**RE: Paseo Nuevo Parking Lot
6321 Holly Ave. NE
Grading & Drainage Plan
Engineer's Stamp Date: 04/01/20
Hydrology File: C18D074A**

Based upon the information provided in your submittal received 04/01/2020, the Grading & Drainage Plan **is not** approved for Grading Permit and Paving Permit. The following comments need to be addressed for approval of the above referenced project:

GRADING AND DRAINAGE PLAN

Date:	No.	Revision:	Date:	Job No.
2/20				2346
Drawn By:	DEC			CP-101
Ckd By:	FCA			SH OF 8

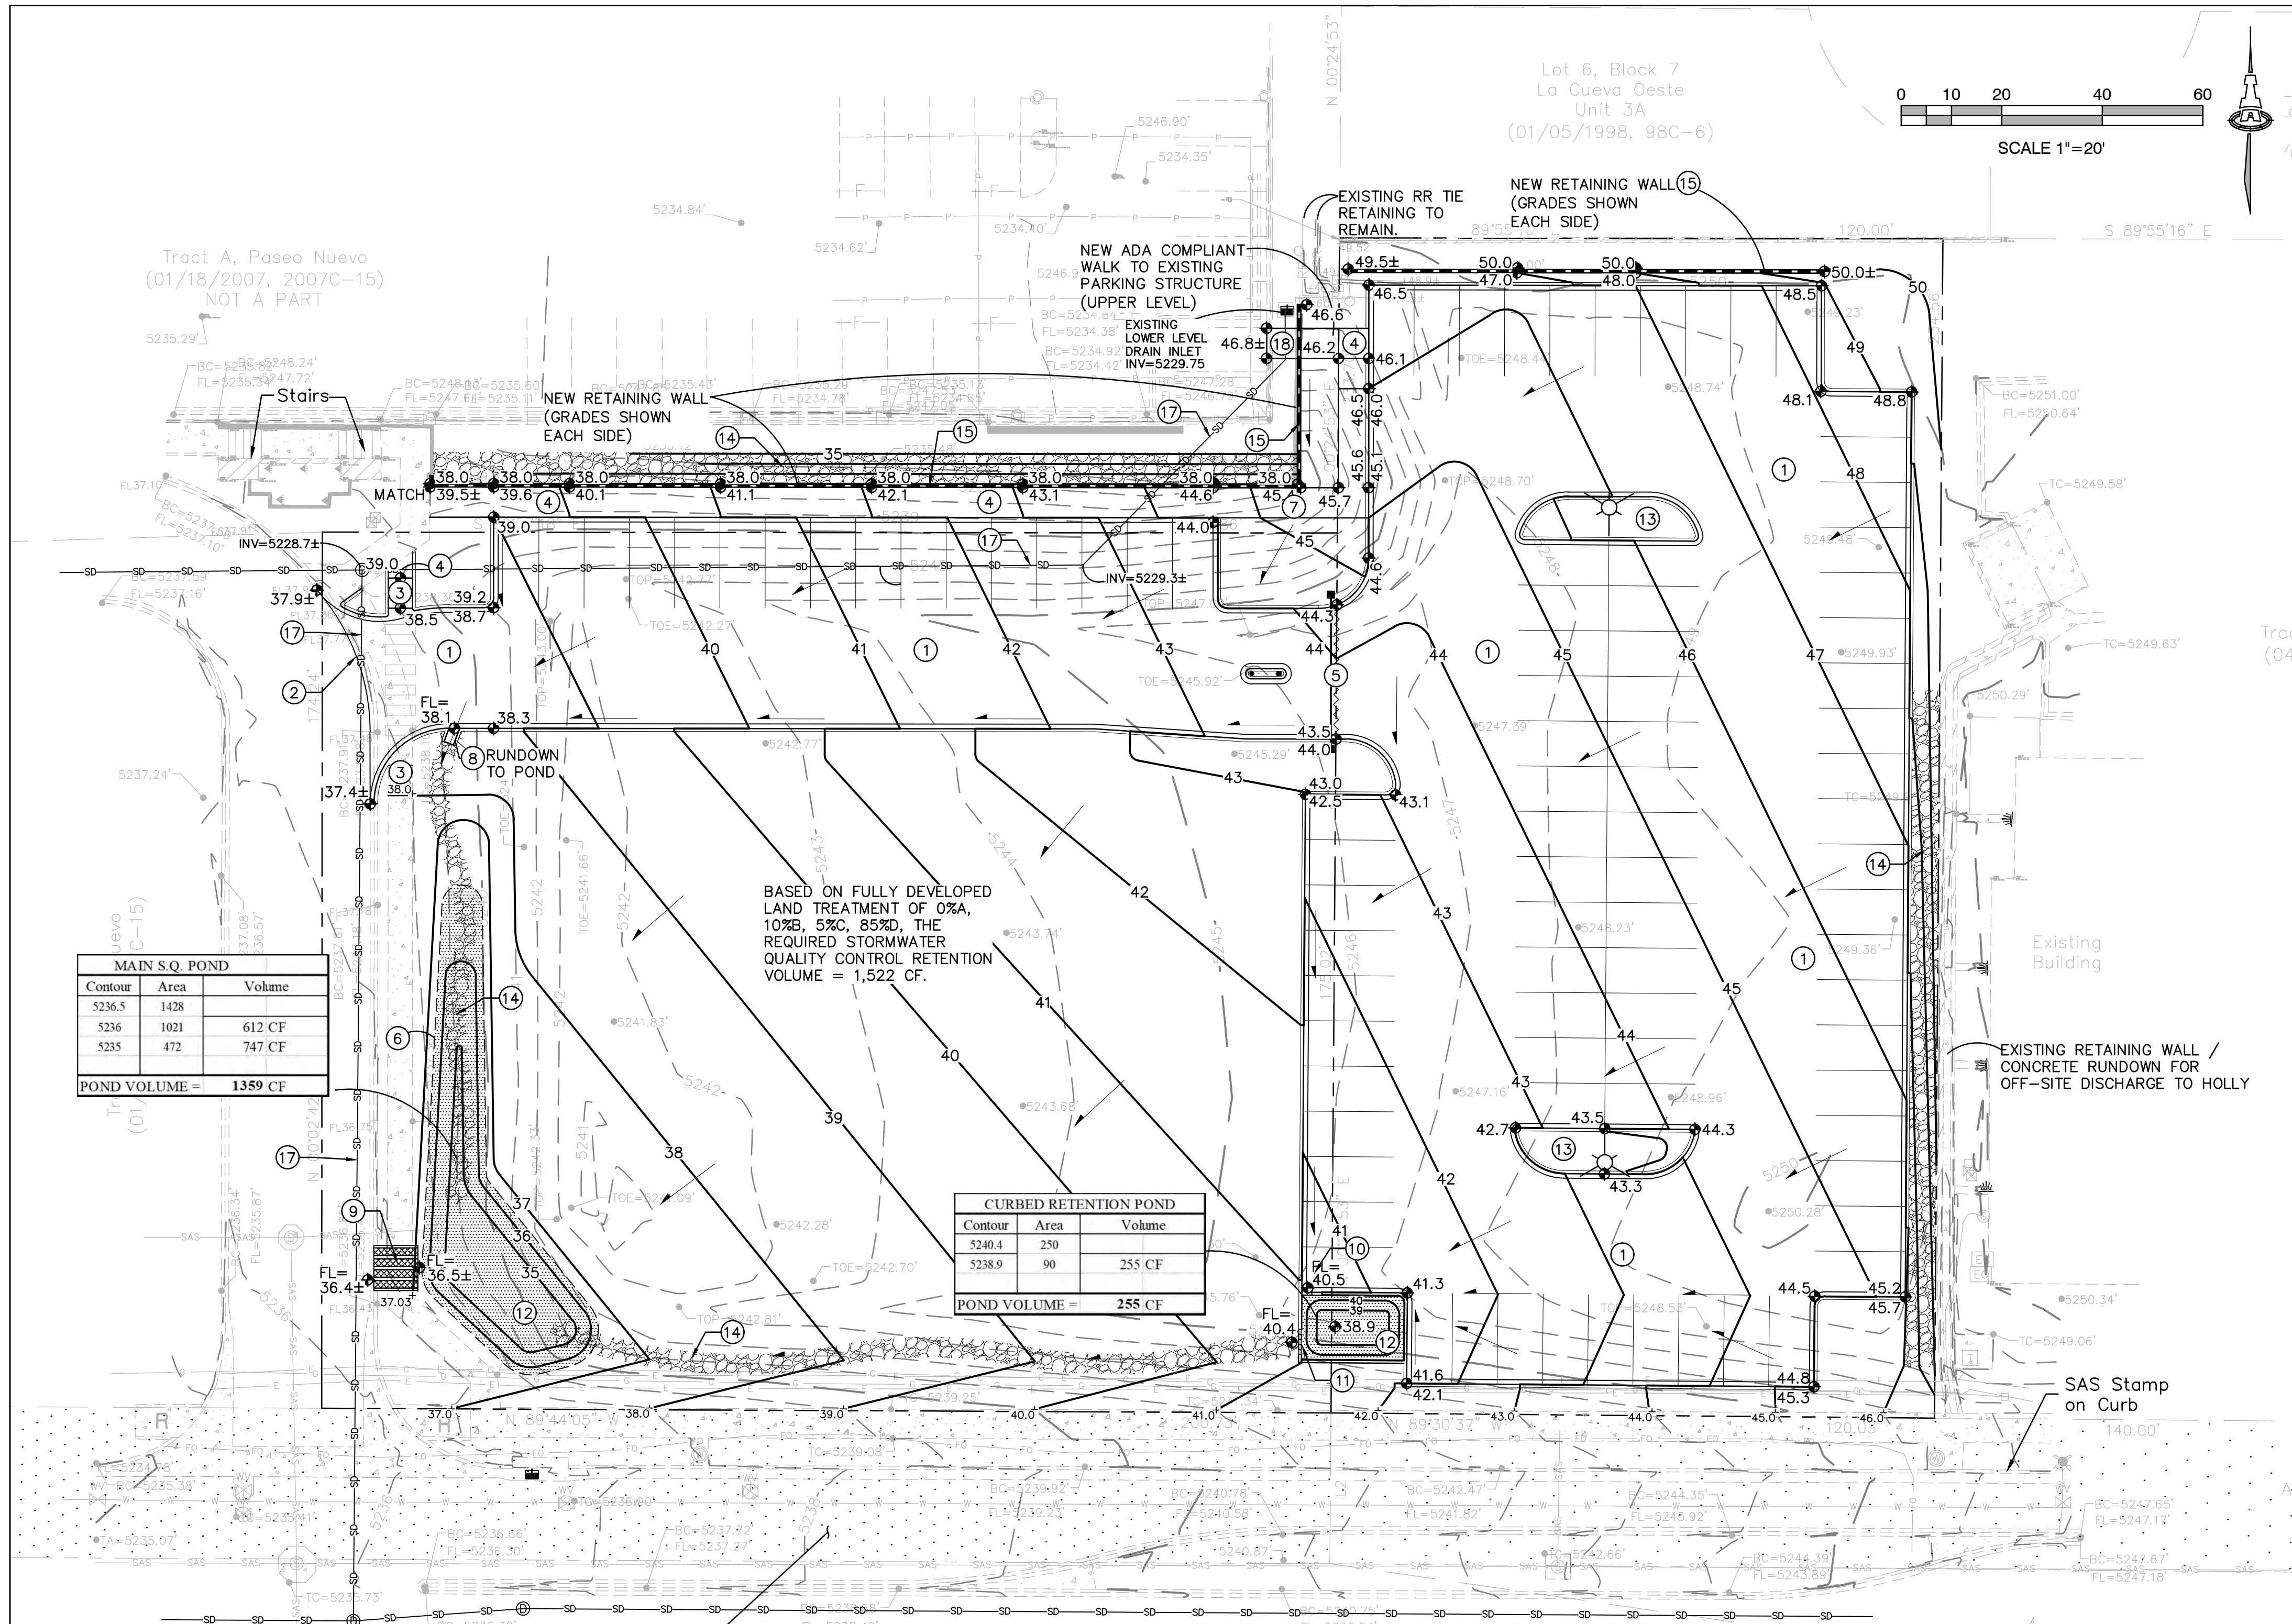
1. Please note that Tract C (0.8275 Ac) is part of the Revised Drainage Report for Paseo Nuevo dated August 2006 by Tierra West. This Tract has the allowable discharge of 3.51 cfs with 20% B cover and 80% D cover. Please adjust all reference and calculations to reflect this.

2. Please note that Tract A (0.6462 ac) is not part of the above referenced Drainage Report. The site must demonstrate adequate downstream capacity per § 14-5-2-12(G) of the Albuquerque Code of Ordinances.
